CITY OF LA VISTA
MAYOR AND CITY COUNCIL REPORT
NOVEMBER 5, 2019 AGENDA

Subject:	Type:	Submitted By:
APPLICATION FOR PUD SITE PLAN – STRECK, INC, LOTS 1 & 16, HARRISON HILLS (S 118 TH ST & EMILINE ST)	◆ RESOLUTION ◆ ORDINANCE RECEIVE/FILE	CHRISTOPHER SOLBERG SENIOR PLANNER

RE: Planned Unit Development – Initial Review
Streck, Inc. – Harrison Hills

RE: Planned Unit Development – 2nd Review
Streck, Inc. – Harrison Hills

PLANNED UNIT DEVELOPMENT
SITE PLAN EXHIBIT

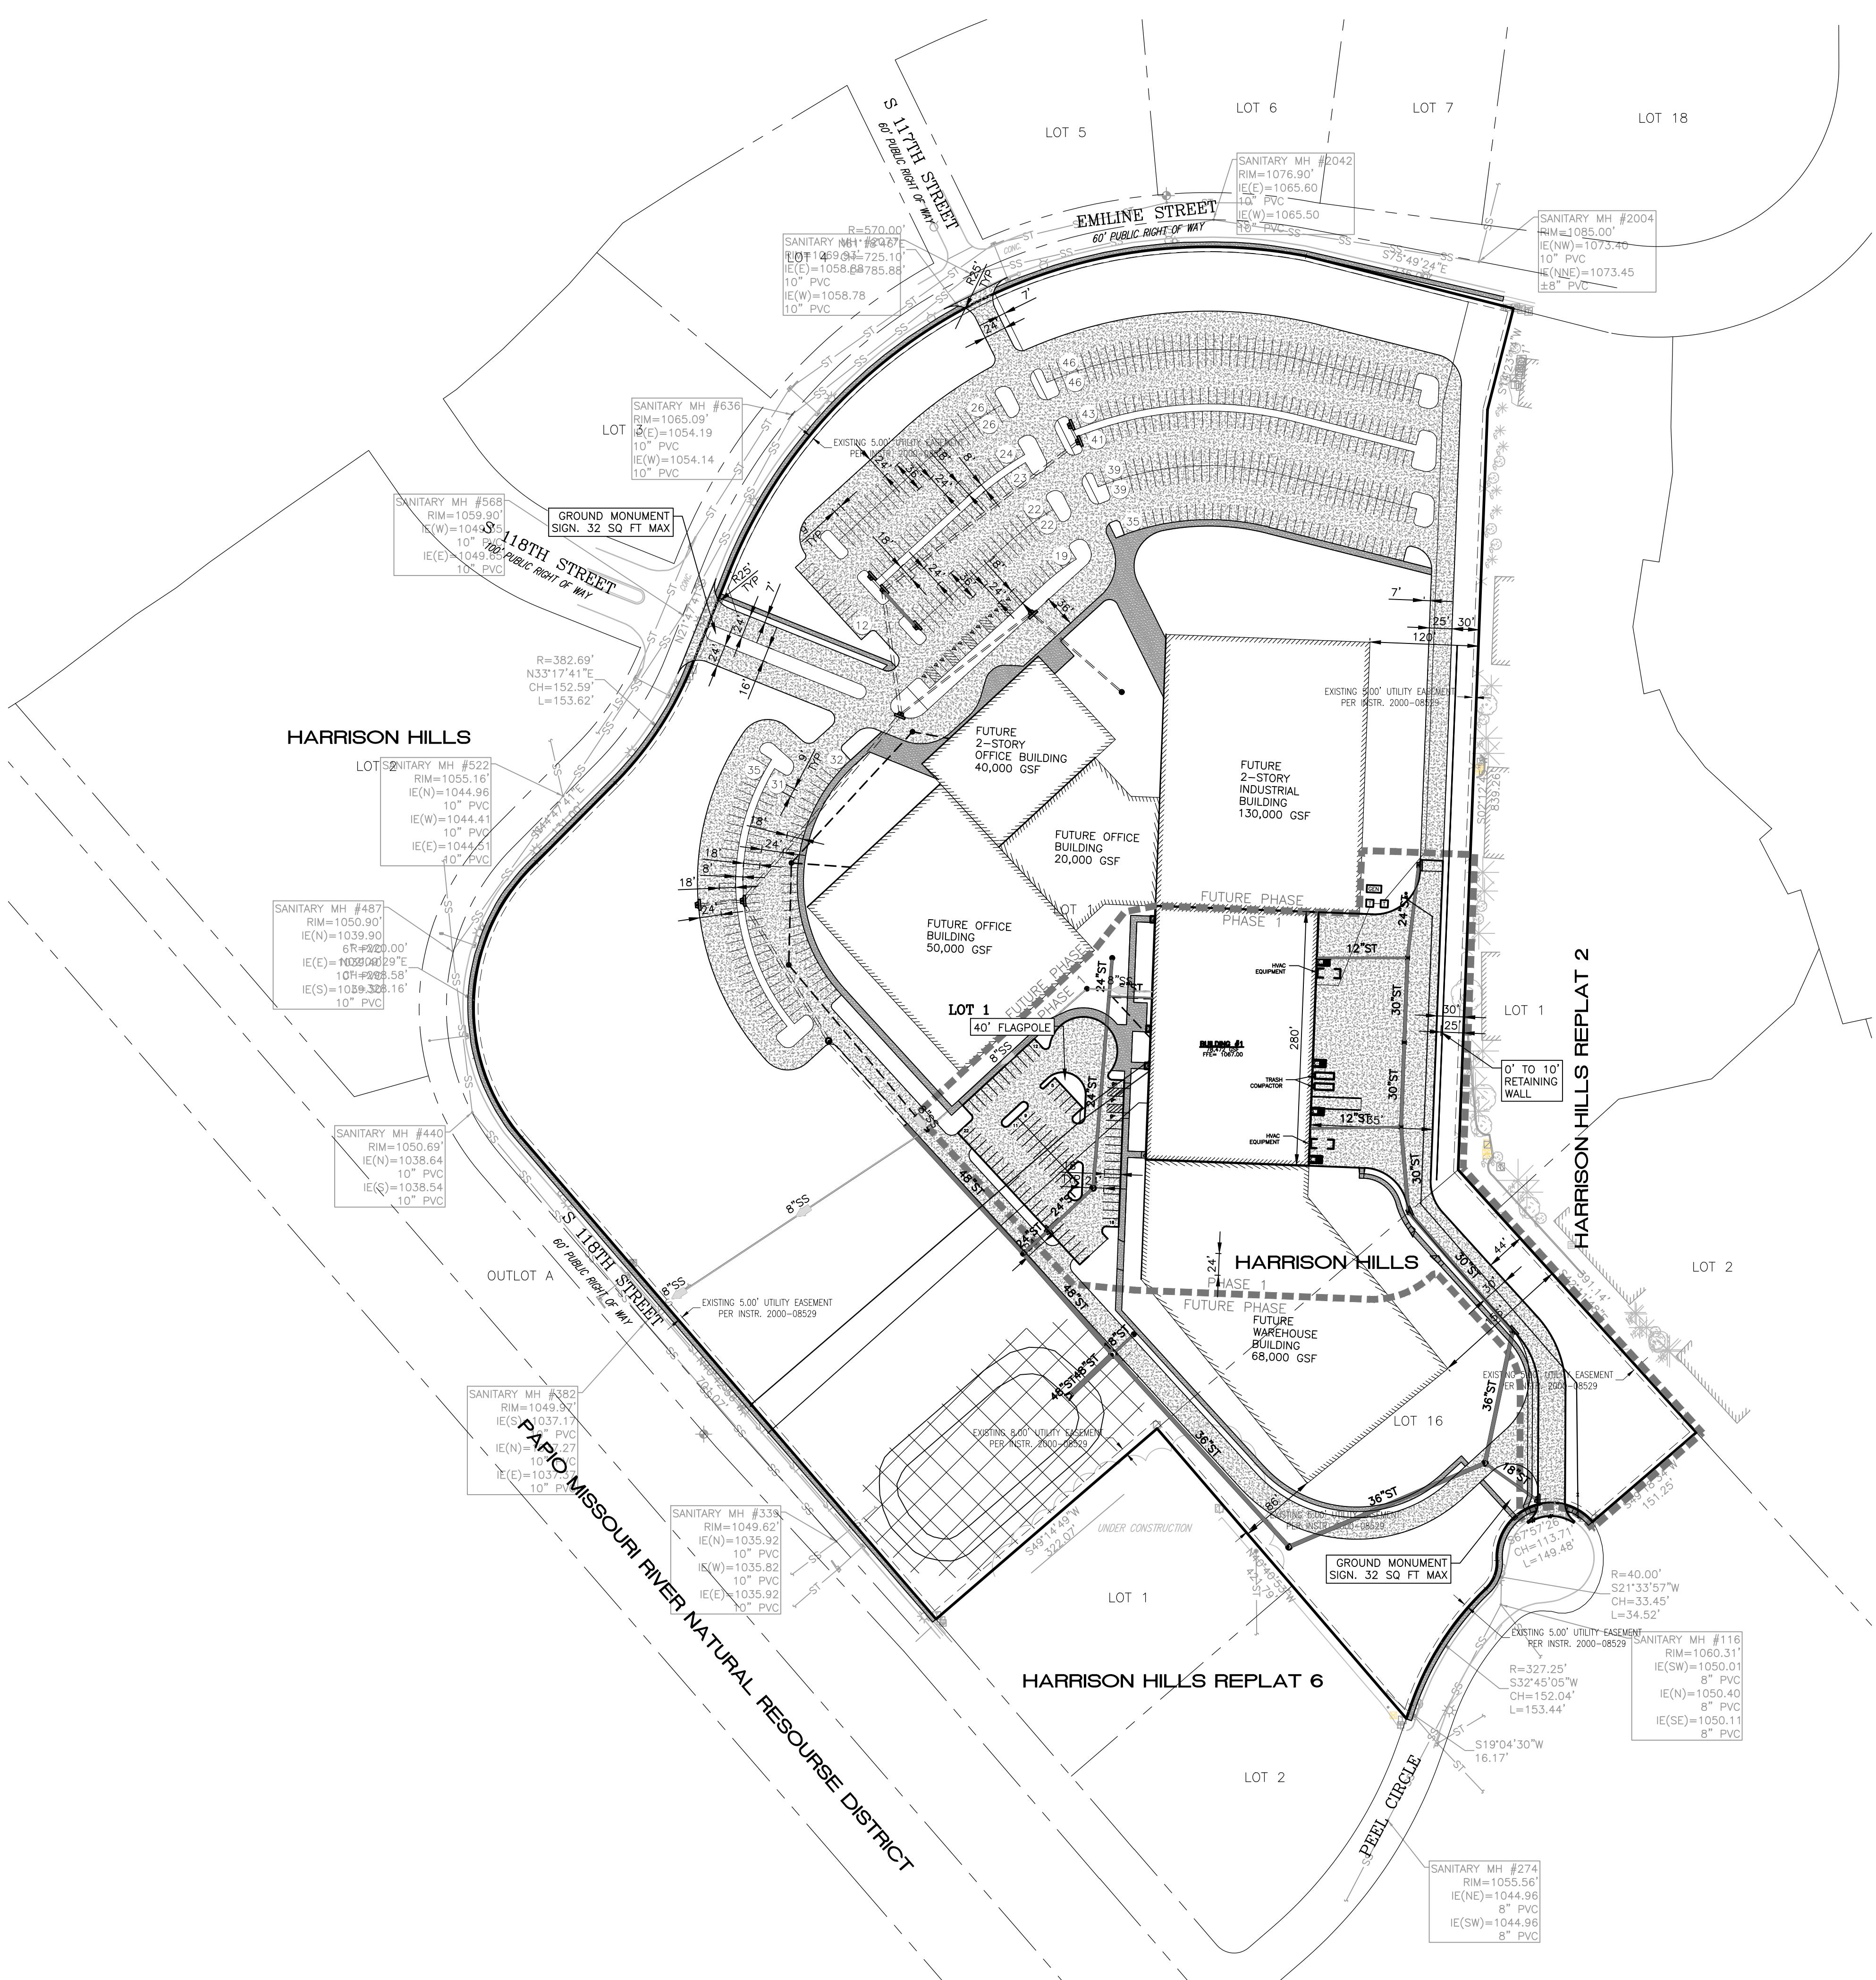
1. Section 5.15.03 – The zoning listed on the PUD Site Plan needs to be corrected to I-1 PUD, Gateway Corridor District (Overlay District) to reflect the actual zoning.

The front yard setback listed on the PUD Site Plan needs to be adjusted to include language that notes the required setback (60 feet) if there is parking in the front yard.

Signage needs to be removed from the PUD Site Plan. Additionally, a 100 square foot monument sign will not be allowed. The additional monument sign along Emilie Street at 117th will not be acceptable. A directional sign, as per the zoning ordinance, would be acceptable in this location.

1. Section 5.15.03 – The zoning listed on the PUD Site Plan needs to be corrected to I-1 PUD, Gateway Corridor District (overlay District) to reflect the actual zoning.

The front yard setback listed on the PUD Site Plan needs to be adjusted to include language that notes the required setback (60 feet) if there is parking in the front yard.

Signage needs to be removed from the PUD Site Plan. Additionally, a 100 square foot monument sign will not be allowed. The additional monument sign along Emilie Street at 117th will not be acceptable. A directional sign, as per the zoning ordinance, would be acceptable in this location.

Response: Agreed, the zoning listed on the PUD Site Plan has been updated.

Response: Agreed, the front yard setback listed on the PUD Site Plan has been updated.

Response: The request for a 100 square foot monument sign has been removed from the PUD Site plan. We have revised the PUD Site Plan to indicate two monument sign locations which will comply with a maximum of 32 square feet of sign area each.
